**ALLEGHENY COUNTY SANITARY AUTHORITY**

**CONTRACT NO. 1735 G, E, H, P**

**ALCOSAN PARKING GARAGE**

**ADDENDUM NO. 2**

ALLEGHENY COUNTY SANITARY AUTHORITY  
WASTEWATER TREATMENT PLANT  
ALCOSAN PARKING GARAGE  
**210-A-44**  
**STAIR 1/ELEVATOR - ELEVATIONS**

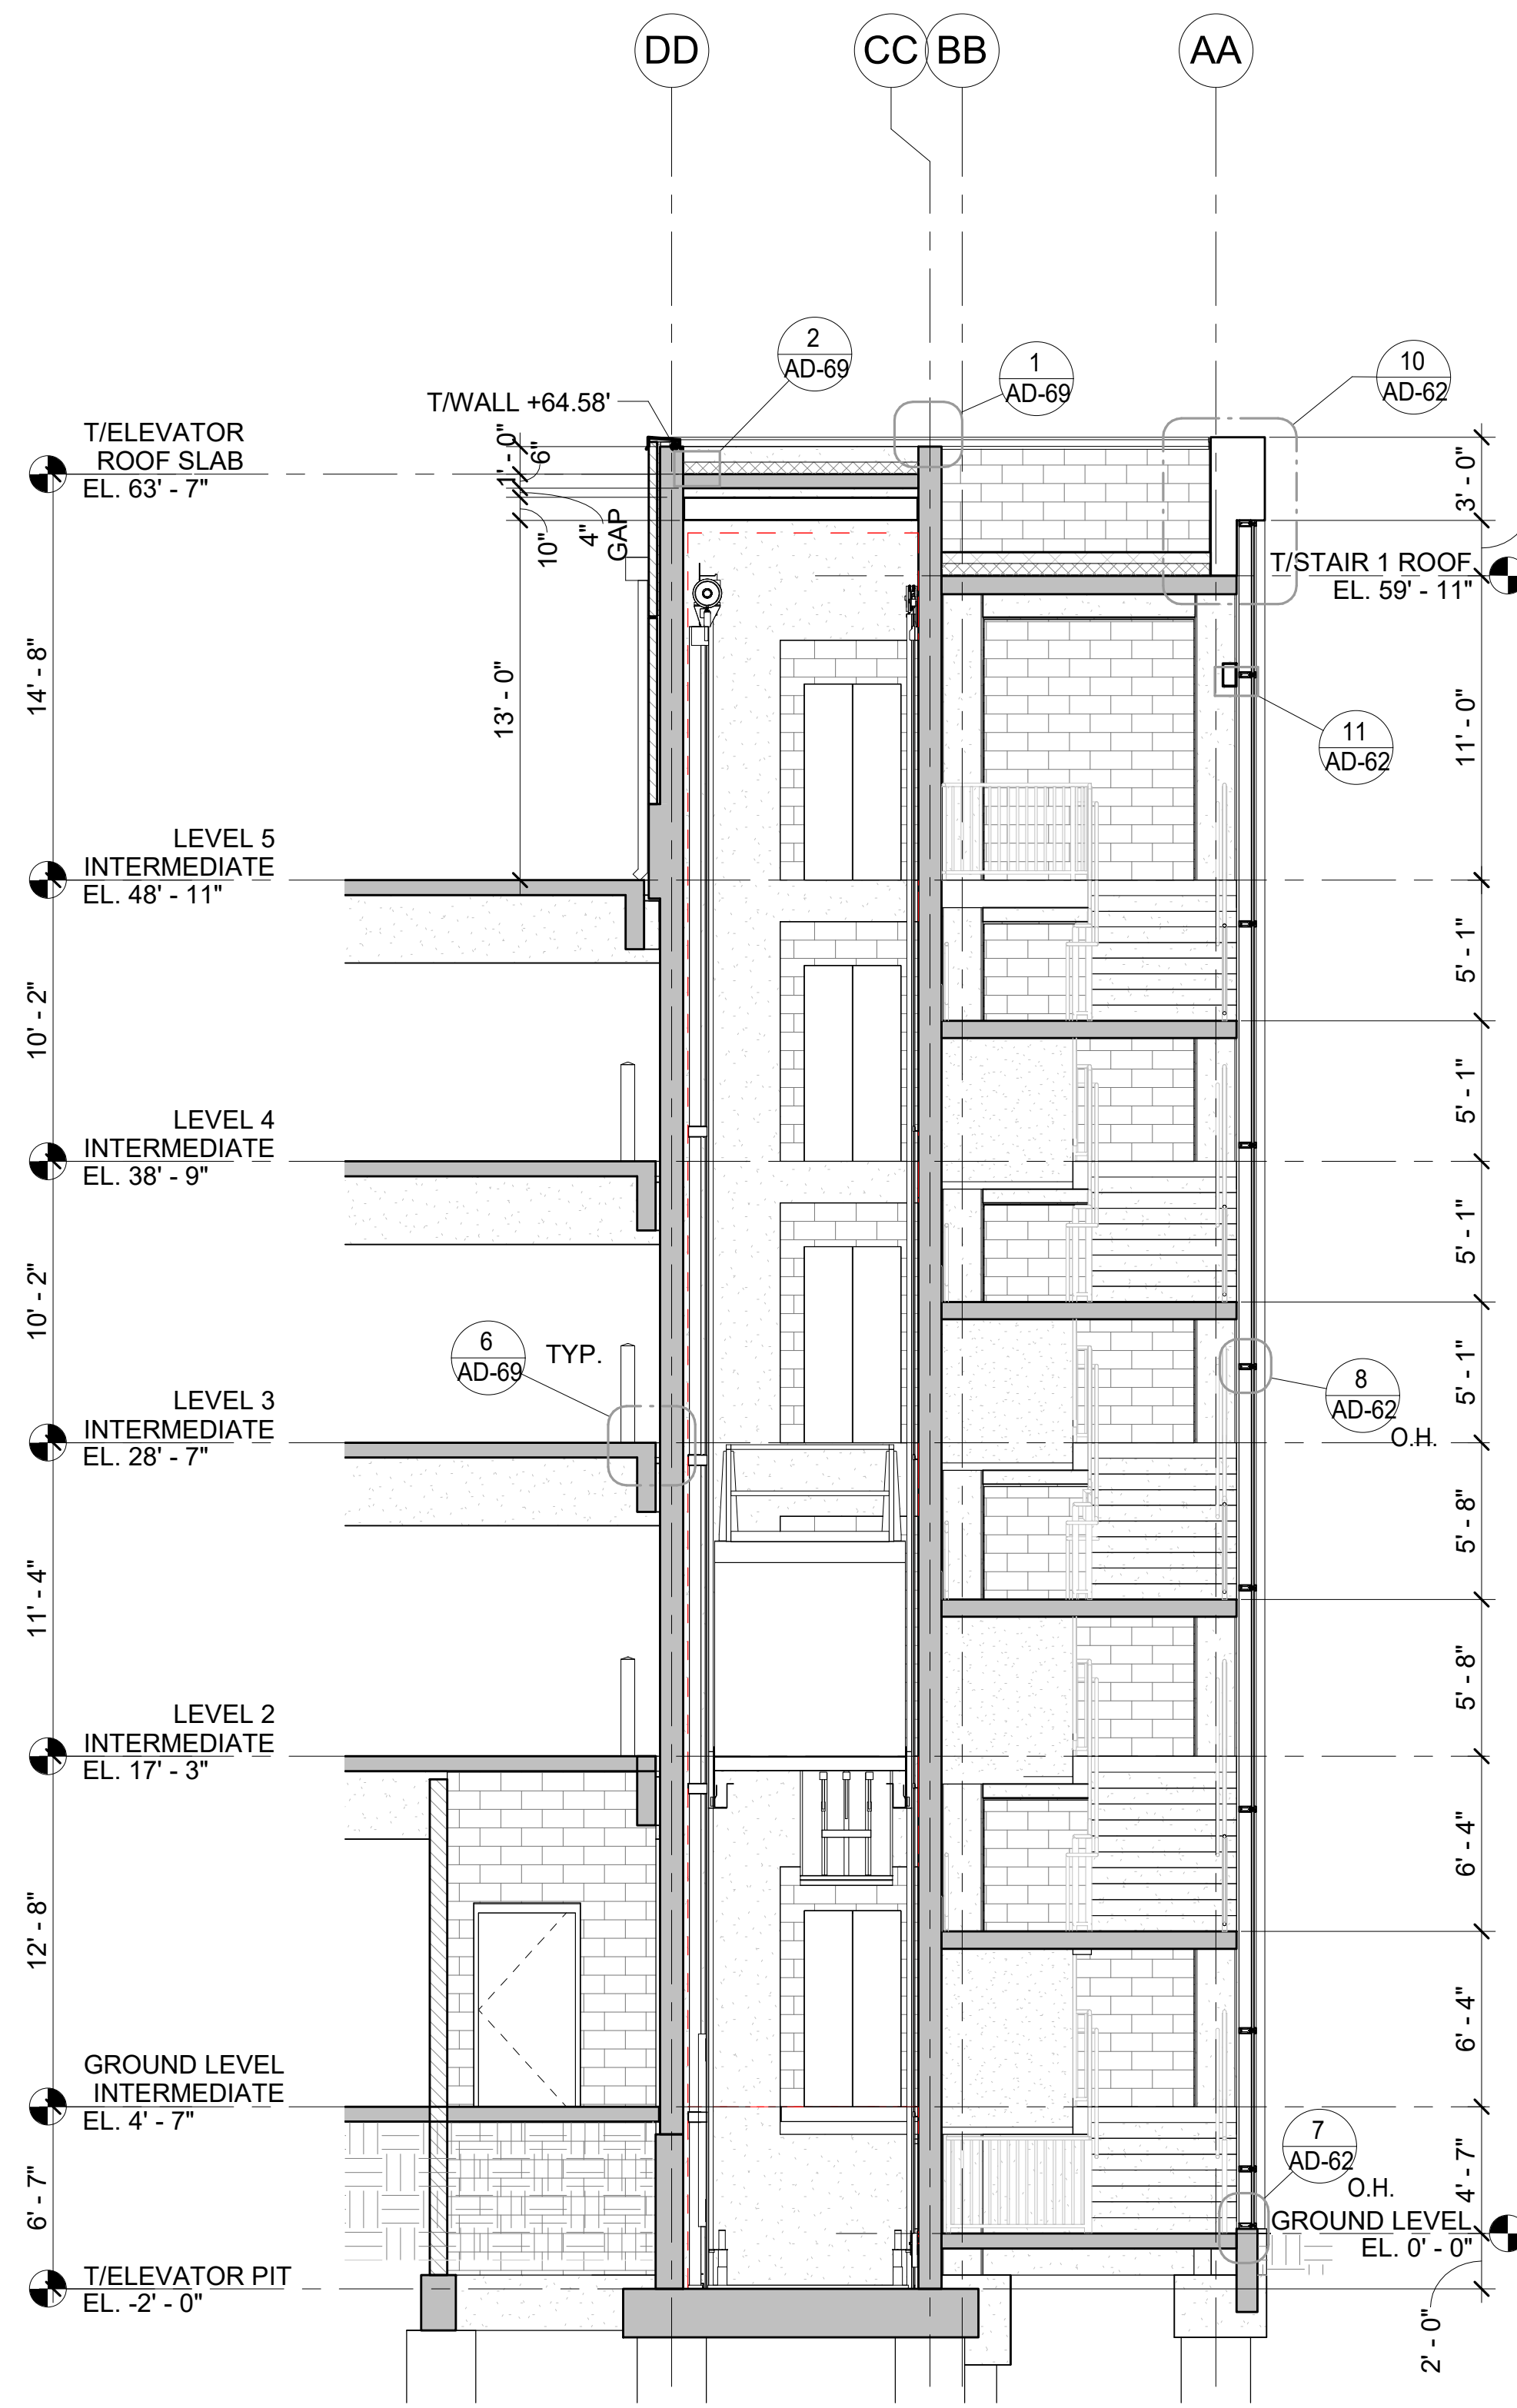
21. Drawing 210-A-44 - STAIR 1 / Elevator - Elevations
  - a. REPLACE with the attached drawing 210-A-44.
  - b. Bar scale is corrected to agree with the elevations.
  - c. General note regarding backer rod and sealant added.

Q39: Reference drawing 210-A-44, A-45, A-51. Question: Drawing Page Scale says 1/4"=1' however all the details on the referenced drawing reference scale 3/16"=1'. Please clarify drawing page scale?

1 STAIR 1/ELEVATOR SECTION LOOKING SOUTH  
A-45 SCALE: 3/16" = 1'-0"

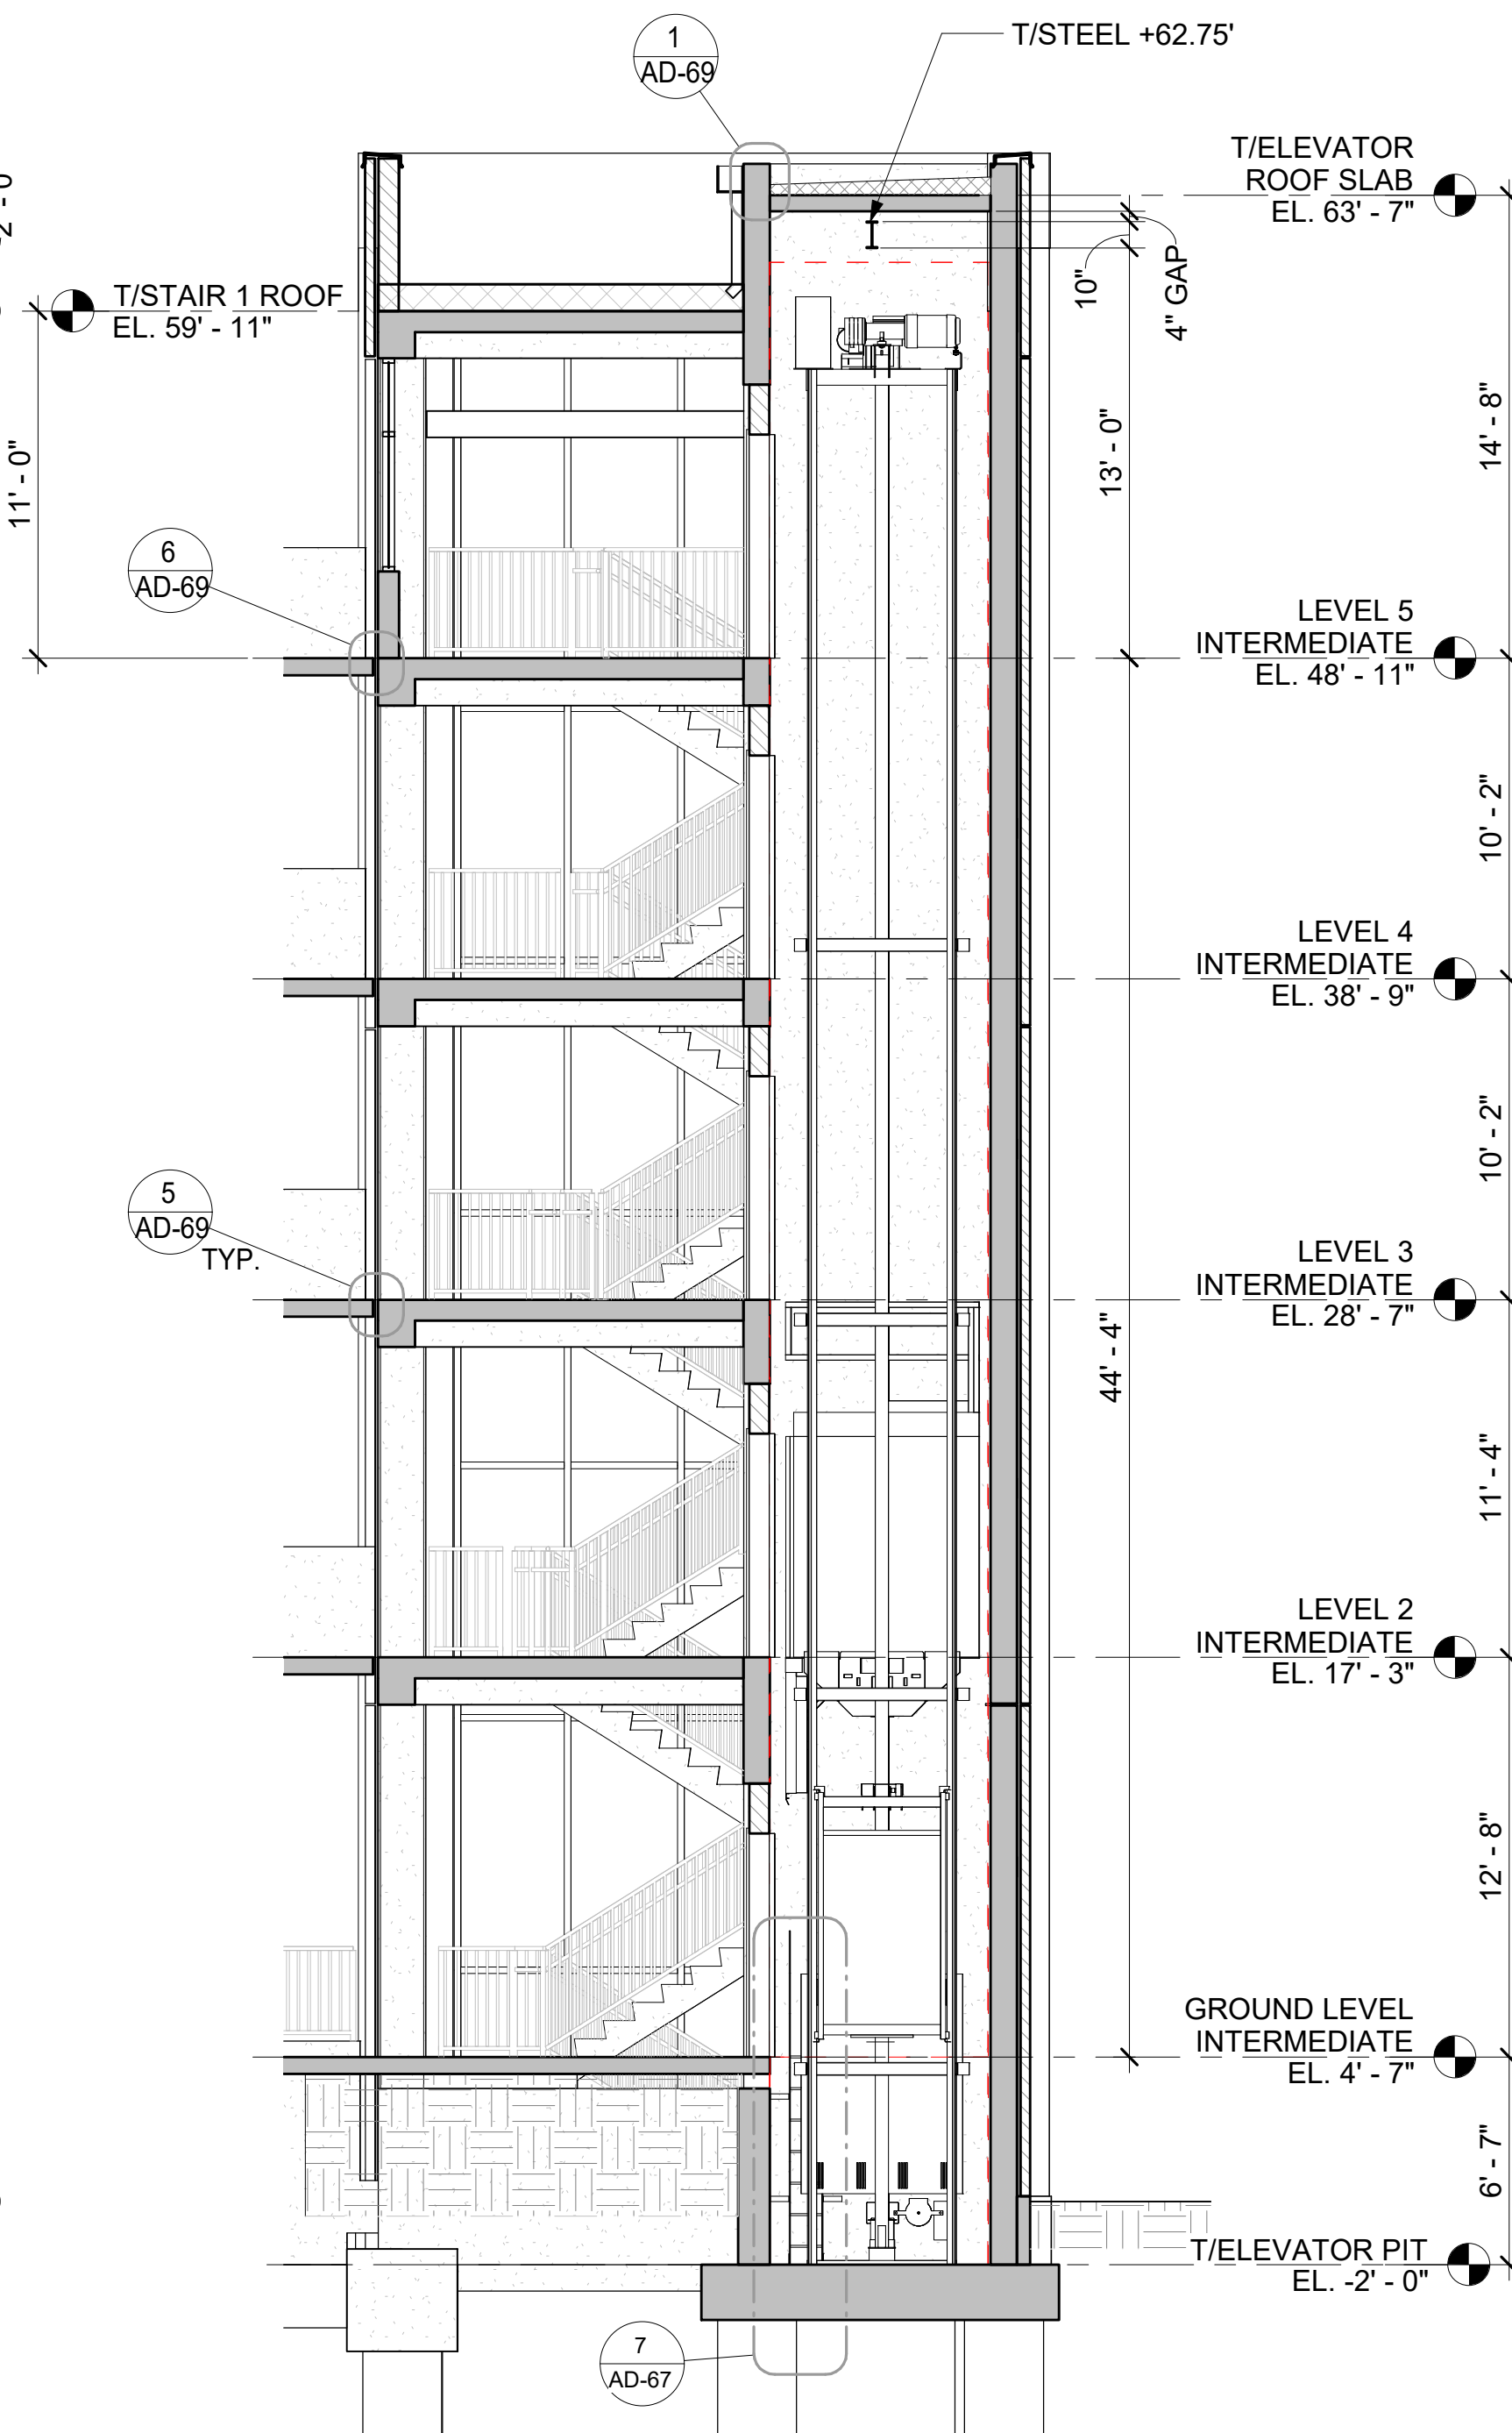
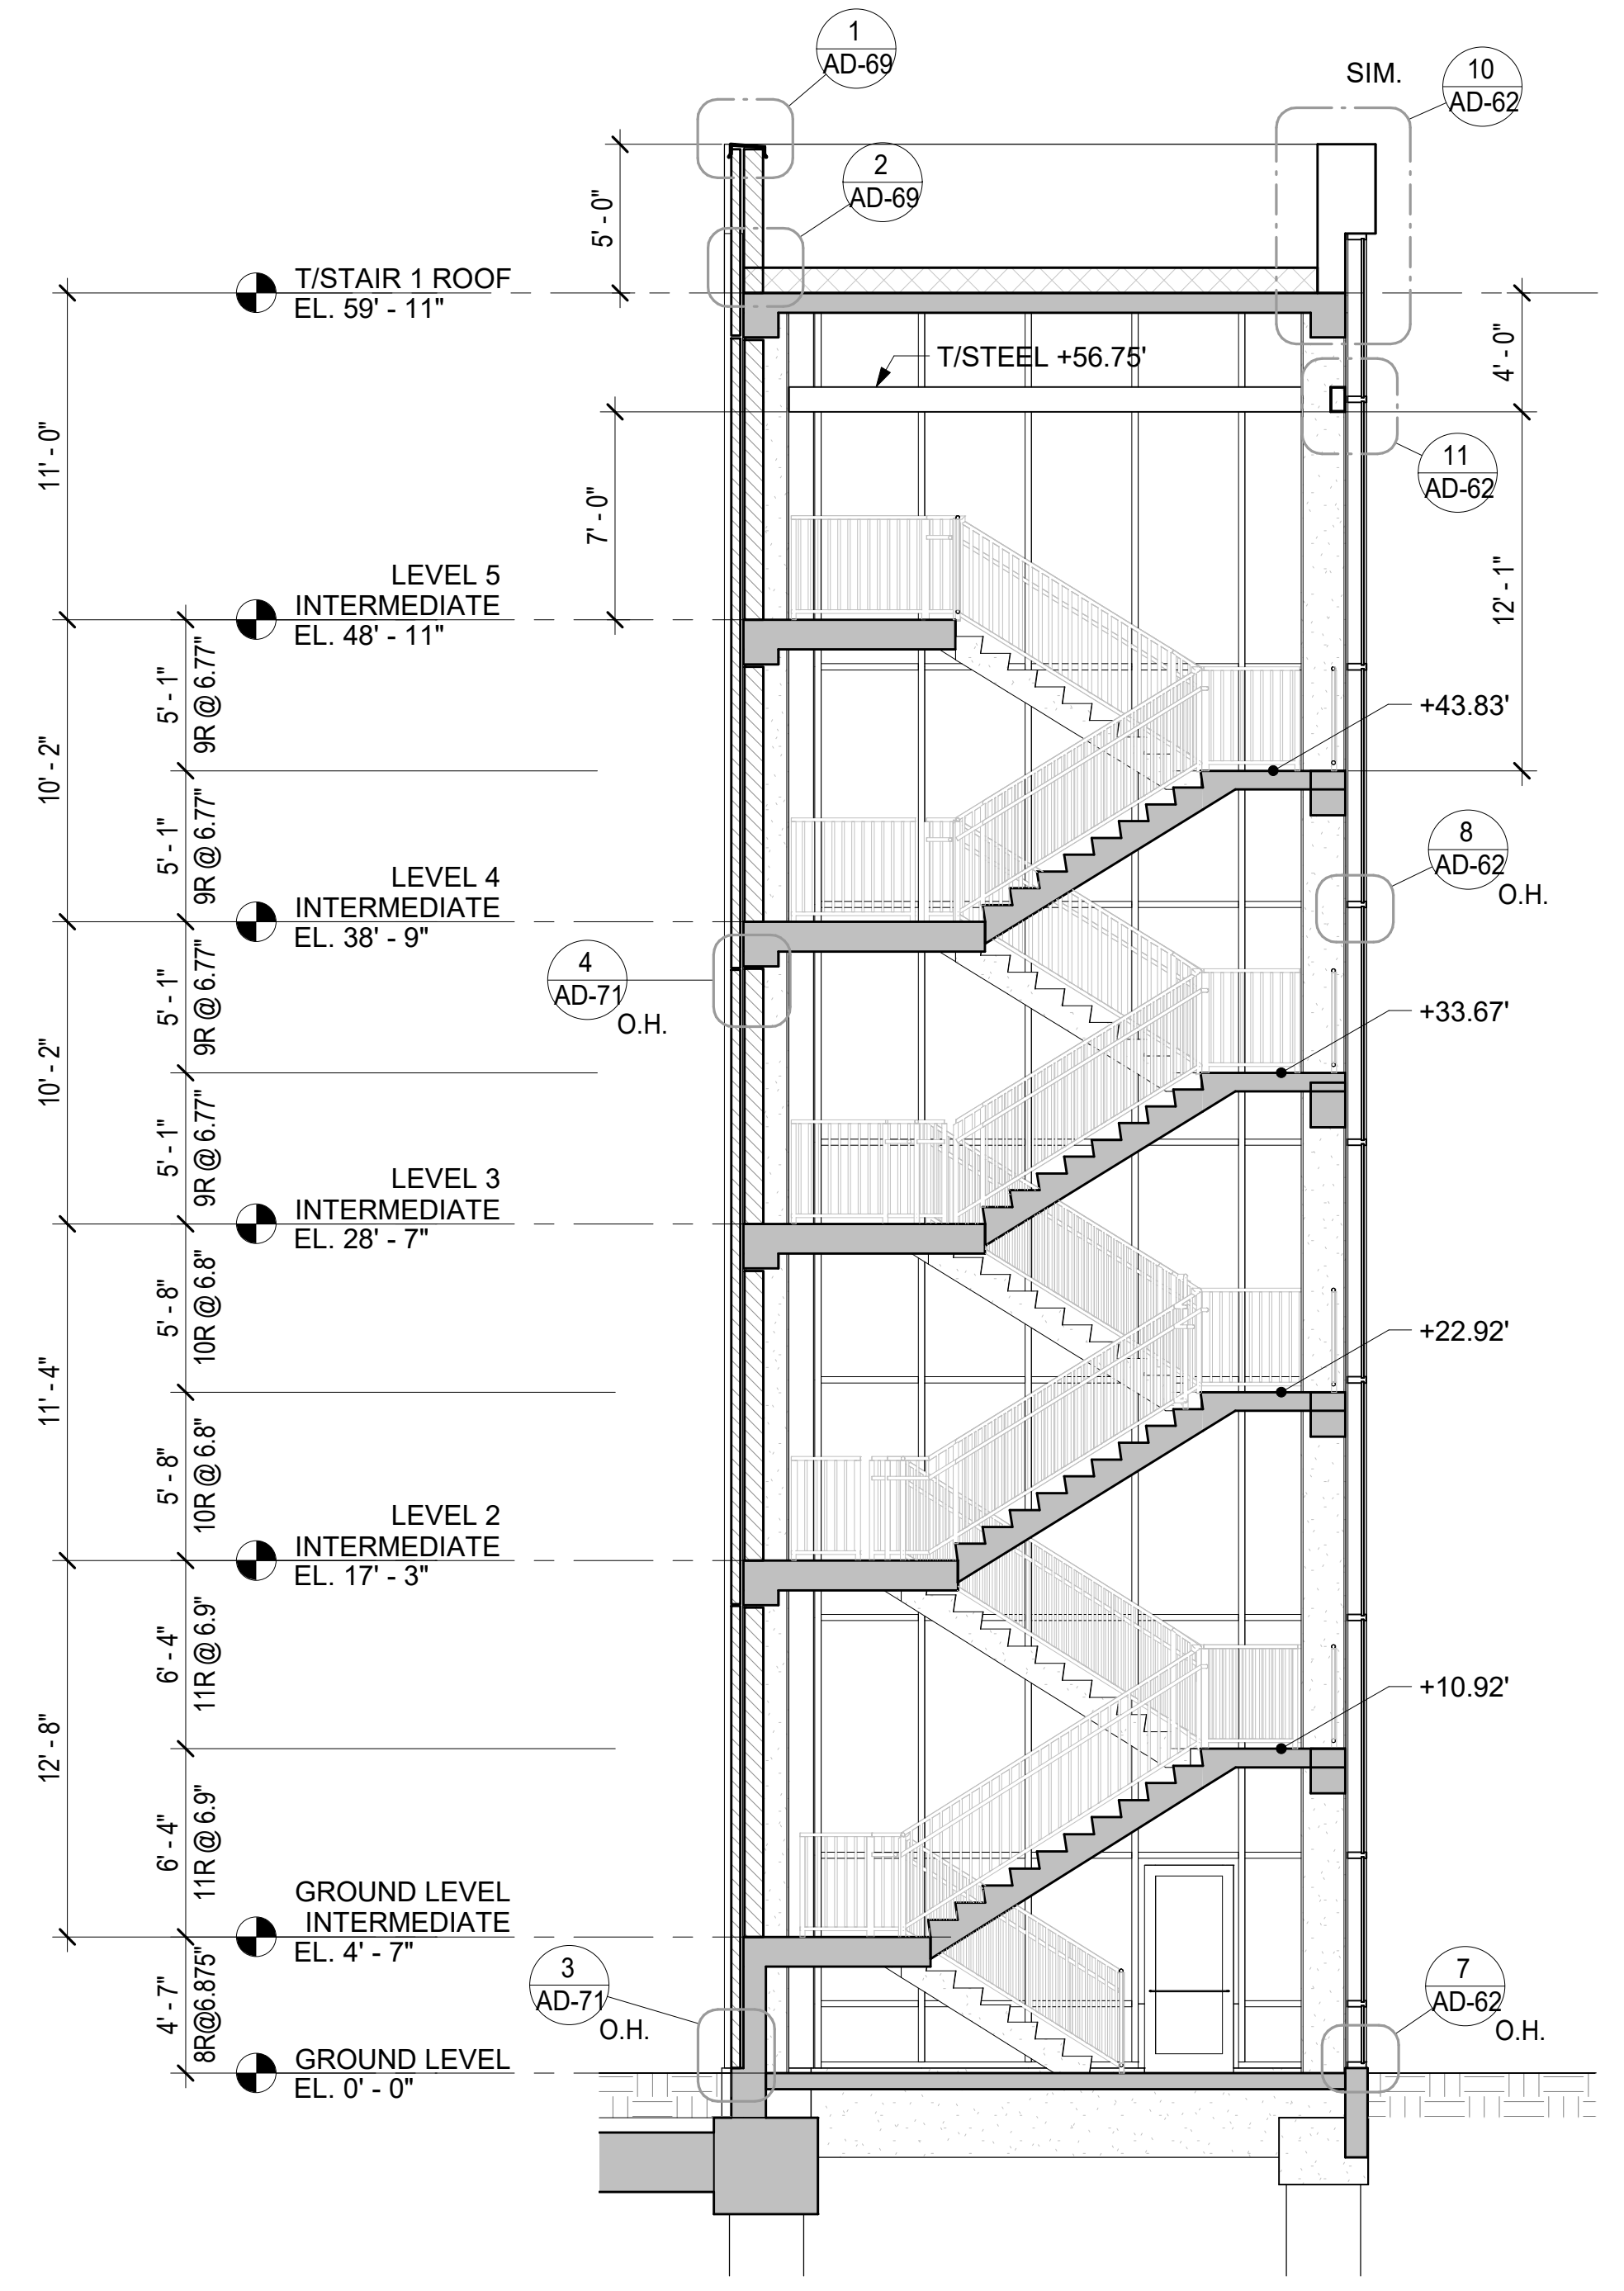
22. Drawing 210-A-45 - STAIR 1 / Elevator - Sections
  - a. REPLACE with the attached drawing 210-A-45.
  - b. Bar scale is corrected to agree with the sections.
